Keep roof water inside the property.

Recommended next detail: an inset right-side gutter, separate terrace drainage and visible emergency outlets

Concept 12 and the original style study remain intact. This supplement proposes drainage relationships; it does not resize the roof, alter room areas or establish a final drainage installation.

PROPOSED COLLECTION PATHS

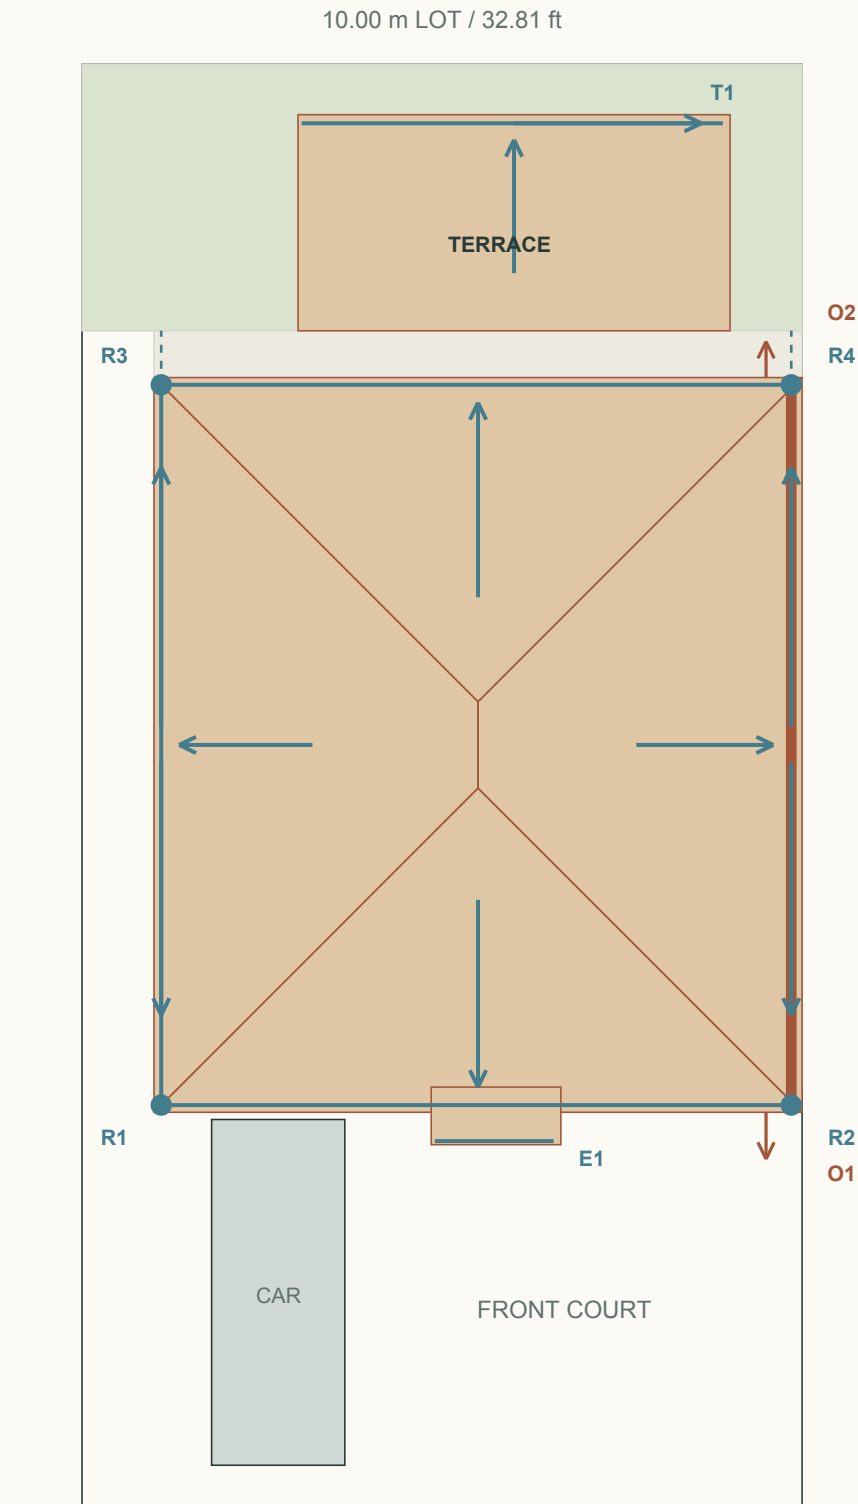
The current roof reaches lot x=10.00 m. An added outside gutter would cross the boundary. Develop a lined collection channel inside that edge, with the tile termination pulled back as needed. Its width, depth and roof support still have to be designed.

Geometry consequence: a real gutter occupies space. Its reserve changes the tiled edge and may affect the hip/ridge geometry. Reconcile that detail before issuing a new roof layout; do not assume every Concept 12 roof dimension survives unchanged.

R1-R4 are candidate outlet zones near the four corners. Split each long side gutter toward front and rear; the front and rear eaves feed their adjacent corners. Pipe count and capacity remain a hydraulic-design decision. O1/O2 mark candidate emergency discharge faces; exact outlet heights and receiving details are unresolved. Keep downpipes on opaque wall piers, clear of glazing, gate travel and entrances.

R3/R4 need a supported transfer across the upper rear setback before descending at the lower rear wall. Keep this route outside the rooms and separate from the terrace roof. Locate inspection access at every concealed change of direction.

T1 collects the terrace at its low garden edge; keep the gutter within the 6.00 x 3.00 m overall envelope. The 1.00 m upper rear setback needs its own continuous waterproofing and outlet. E1 drains the small entry shade away from the doorway. Do not dump upper-roof water onto the terrace tiles or entry path.

Right boundary / inset channel

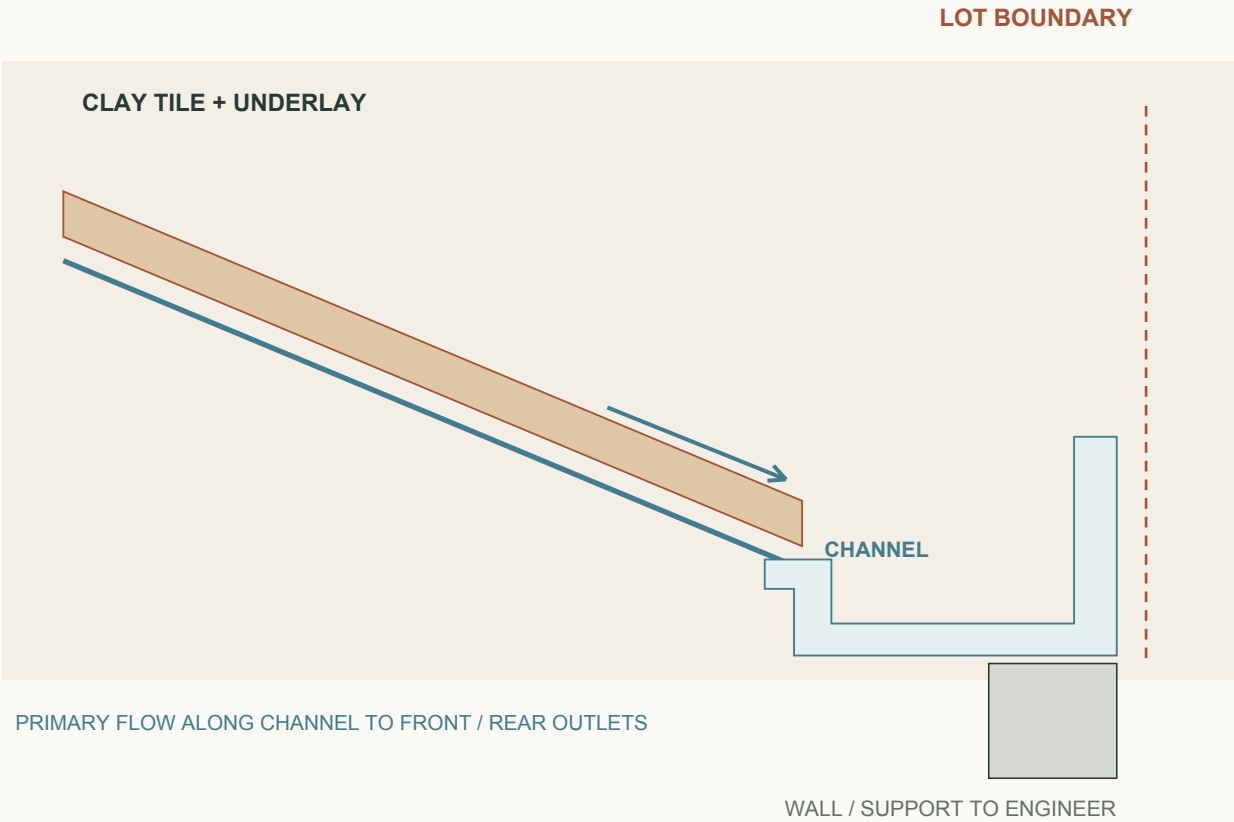
1. A continuous compatible lining, roof-underlay discharge into it, supported edges and provision for movement. Keep joints inspectable; test the lined channel before covering adjacent work. [2]
2. Primary outlets plus a separate overflow path positioned above normal drainage but below the level that would allow water into the building. Discharge overflow visibly on an in-lot front/rear face, away from the doorway and neighbor. Final elevations require design. [3]
3. Safe access to clean the full channel, outlets and roof junctions. A narrow void behind the roof is not a maintenance strategy. Detail access from the property with the roof contractor; do not assume walking directly on tiles. [4]

The sketch reserves a relationship, not a channel size. Structure, lining material, edge heights and water capacity remain open.

Rear setback / canopy junction

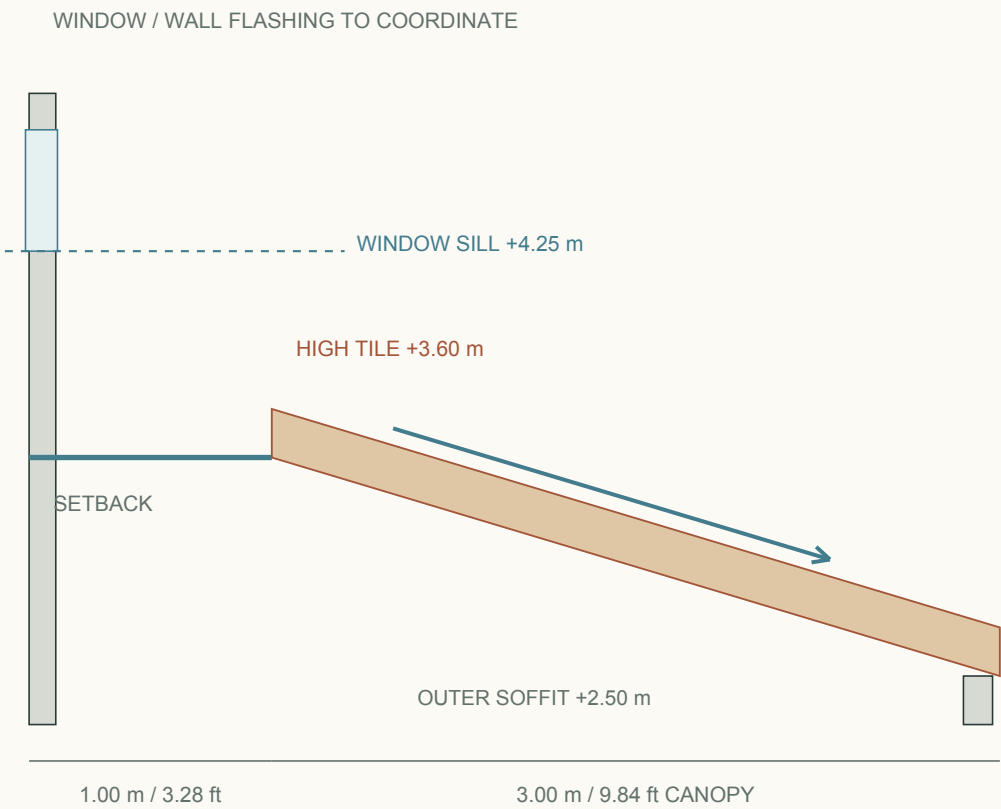
The upper roof ends above the 1.00 m rear setback. Waterproof the entire setback, including the portion below the upper eave, and carry the membrane into a flashed junction at the terrace attachment. The canopy high edge is 0.20 m above the +3.40 m floor datum; its actual support and wall termination need a section.

The selected canopy top at +3.60 m leaves 0.65 m below the upper window sill. That is a geometric difference, not a verified flashing or access clearance. Keep upper-roof downpipe discharge in a pipe through the transfer, rather than spilling across this junction.

Provide a low-edge terrace gutter with an inspectable outlet at an outer post zone. Coordinate its depth, beam/soffit and tile edge while retaining the 2.50 m outer clear soffit and the 0.70 m strip beyond the canopy.

Tile slope check: 30% is about 16.7 degrees, not 30 degrees. The chosen tile assembly must suit the local exposure and roof lengths. [1]
